Agenda Item #4

Application 2026-30-CA

960 Dauphin Street

After-the-fact approval to remove original doors, transoms, and sidelights from the south façade and replace with new wood doors that do not match existing.

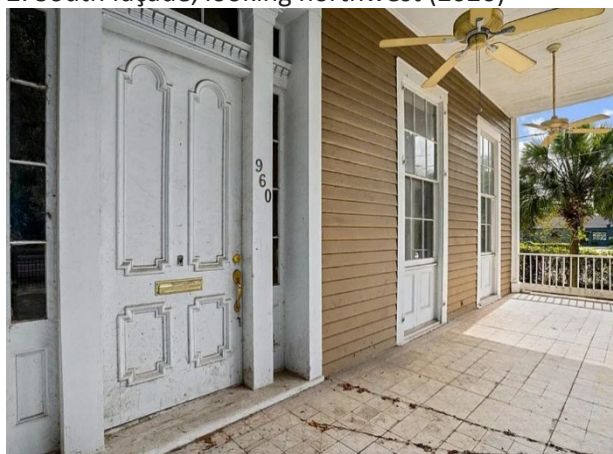
While staff agree that the main entry showed considerable signs of wear, onsite inspections during the construction process indicated that the paneled wood door, sidelights, transom, and decorative trim could be repaired. Staff received no communication during the construction process that repair of the either of the two façade door assemblies was not possible. To the contrary, prior to their removal, both façade doors and their surrounds had been repaired and painted in the white and black color scheme used on the rest of the residence. New hardware had been installed on the main entry door, suggesting it was operable. Upon receiving a 311 complaint that both doors had been replaced, staff visited the site and found that the contractor had salvaged both doors as well as their decorative surrounds, transoms, and sidelights. Workmen onsite assured staff that the doors and surrounds could be reinstalled in their original location and condition.

If for any reason the doors and surrounds could not be reinstalled, the *Guidelines* specify that a new door and surrounds would need to match the original as closely as possible. Since the original door and trim survive, it would be possible to have them replicated exactly in an insect-resistant wood such as mahogany. In contrast, the current replacement doors do not replicate any detail of the original. The original single-leaf entry door with transoms has been replaced with a double-leaf door without transoms. The new trim is lacking in the characteristic detail and depth of the original Italianate door surrounds. The new multi-light doors are themselves a significant departure from the historic solid wood paneled doors.
